RS-09-036

Dresden Nuclear Power Station, Units 2 and 3
Renewed Facility Operating License Nos. DPR-19 and DPR-25
NRC Docket Nos. 50-237 and 50-249

Quad Cities Nuclear Power Station, Units 1 and 2
Renewed Facility Operating License Nos. DPR-29 and DPR-30
NRC Docket Nos. 50-254 and 50-265

Subject: Request for License Amendment to Technical Specification (TS) 3.4.5, "RCS Leakage Detection Instrumentation," TS 5.6.5, "Core Operating Limits Report (COLR)," and Renewed Facility Operating License

TS Page 3.4.5-2

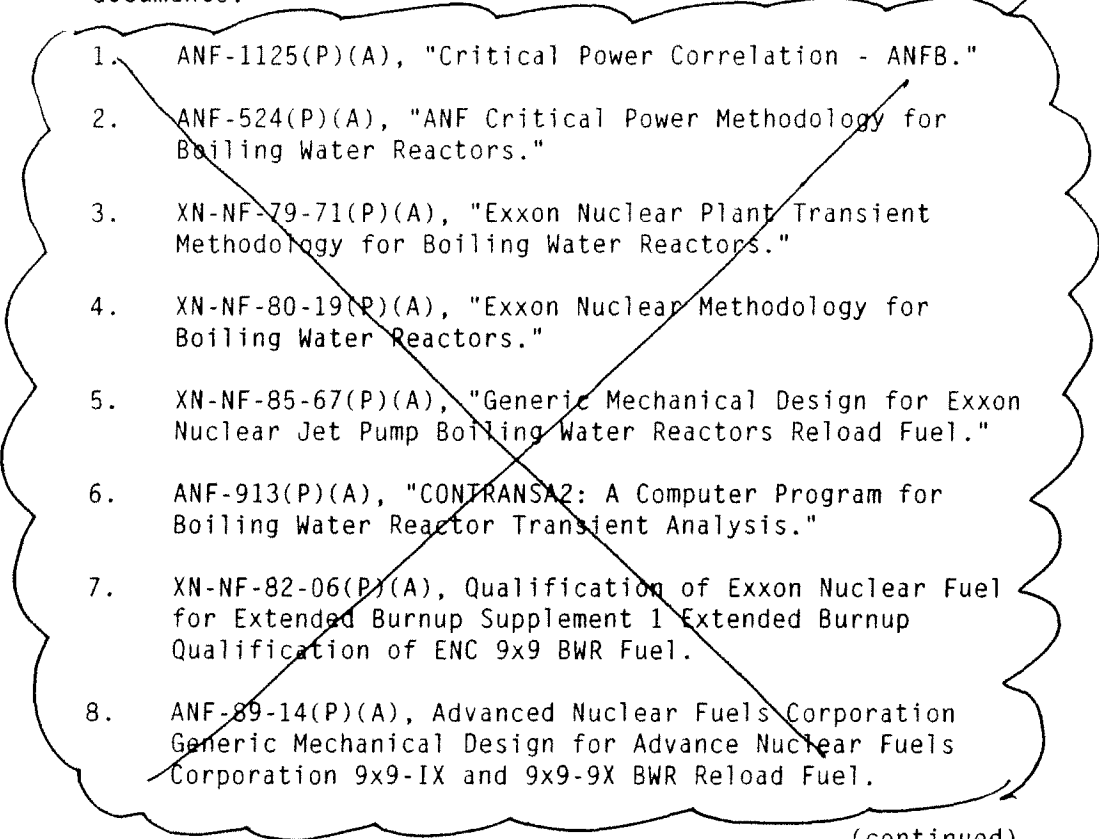
(a) For Unit 3 only, the drywell/equipment drain sump monitoring system may be used to satisfy requirements applicable to the drywell floor drain sump monitoring system until the system is repaired during a Unit 3 outage of sufficient duration, but no later than startup from 03R20. ee

(a) For Unit 3 only, the drywell equipment drain sump monitoring system may be used to satisfy requirements applicable to the drywell floor drain sump monitoring system until the system is repaired during a Unit 3 outage of sufficient duration, but no later than startup from D3R20.

- LCO 3.4.5.a: Delete footnote (a) symbol modifying "system"
- Condition A.: Delete footnote (a) symbol modifying "system"
- Required Action A.1: Delete footnote (a) symbol modifying "system"
- Page 3.4.5-1: Delete footnote (a) text
- SR 3.4.5.2 and 3.4.5.3: Delete footnote (a) symbol modifying "system"
- Page 3.4.5-2: Delete footnote (a) text

Renewed Facility Operating License DPR-30, Page 7

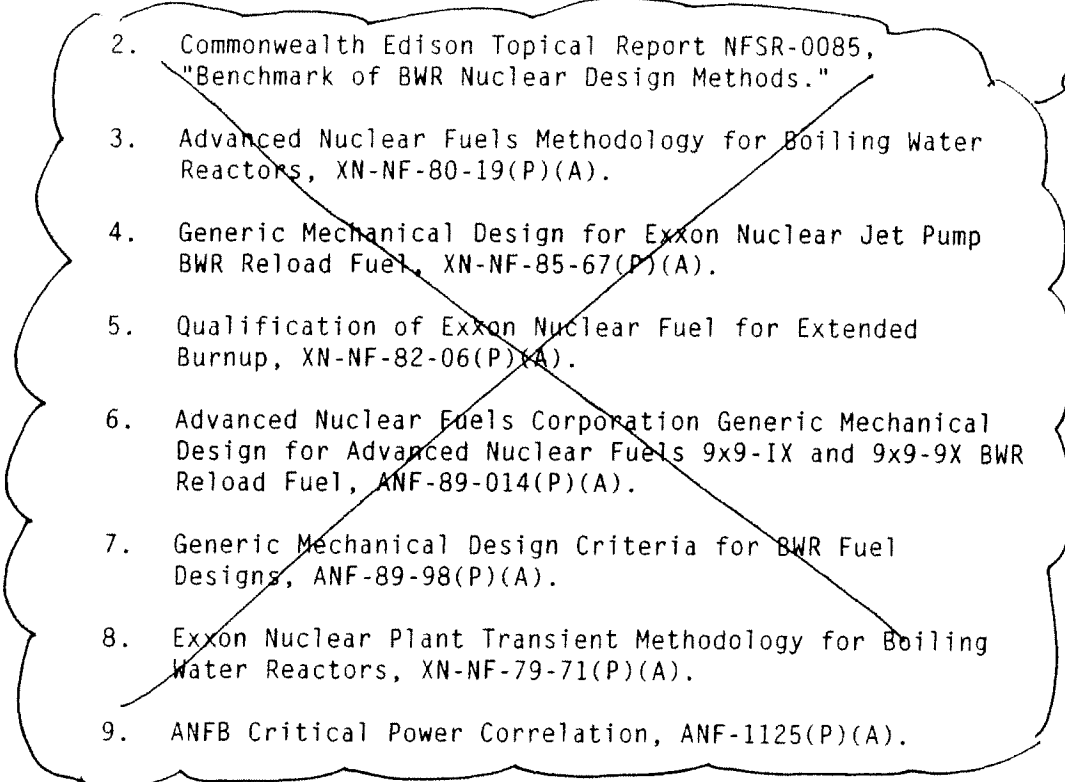
Deleted

T.

Fuel Burnup

The maximum rod average burnup for any rod shall be limited to ~~60~~ GWD/MTU until the completion of an NRC environmental assessment supporting an increased limit.

- 2.3. QCNPS TS 5.6.5, "Core Operating Limits Report (COLR)," paragraph b
 - o Item 17: Delete the term "BWR Owners' Group"
 - o Item 23: Delete the proprietary and approved nomenclature (i.e., "-P-A") for CENPD-287 and the comma between "Reactors" and "Supplement"
 - o Delete Items 2 through 12, and 14 through 16
 - o Renumber QCNPS TS 5.6.5.b Items 13, and 17 through 24
- 2.4. DNPS Renewed FOLs DPR-19 and DPR-25
 - o Delete license condition 9, "Fuel Burnup," of Renewed Facility Operating License DPR-19
 - o Delete license condition Q, "Fuel Burnup," of Renewed Facility Operating License DPR-25
- 2.5. QCNPS Renewed FOLs DPR-29 and DPR-30
 - o Delete license condition U, "Fuel Burnup" of Renewed Facility Operating License DPR-29
 - o Delete license condition T, "Fuel Burnup," of Renewed Facility Operating License DPR-30
